# UNITED STATES PATENT AND TRADEMARK OFFICE

APPLICATION NO.	FILING DATE	FIRST NAMED INVENTOR	ATTORNEY DOCKET NO.	CONFIRMATION NO.
10/720,652	11/24/2003	Seong-Yong Hwang	21C-0098	4656
23413	7590	05/09/2006	EXAMINER	
CANTOR COLBURN, LLP 55 GRIFFIN ROAD SOUTH BLOOMFIELD, CT 06002			CHOWDHURY, TARIFUR RASHID	
			ART UNIT	PAPER NUMBER
			2871

<b>Office Action Summary</b>	<b>Application No.</b> 10/720,652	<b>Applicant(s)</b> HWANG ET AL.	
	<b>Examiner</b> Tarifur R. Chowdhury	<b>Art Unit</b> 2871

*Fig. 2*

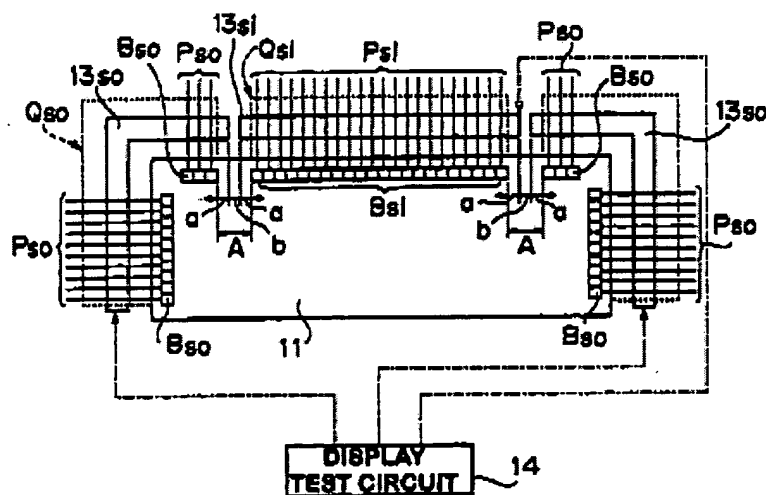
6. Shibatani discloses (col. 7, line 57 – col. 8, line 11) and shows in Fig. 2, a circuit device comprising:

- electrode terminals linearly aligned in a plurality of columns along a first direction parallel to an edge line of a semiconductor substrate (11) and linearly aligned in a plurality of rows along a second direction perpendicular to the first direction and bumps disposed on the electrode terminal (col. 7, lines 57-65),

wherein distances between adjacent two electrode terminals aligned in the first direction are uniform as well as distances between the adjacent two electrode terminals aligned in the second direction are uniform (col. 7, line 66 – col. 8, line 11).

Accordingly, claim 1 is anticipated.

As to claim 3, it is clear from Fig. 2 of Shibatani that each of the bumps (Bsi, Bso) has a rectangular shape when viewed from an upper side of the bumps.
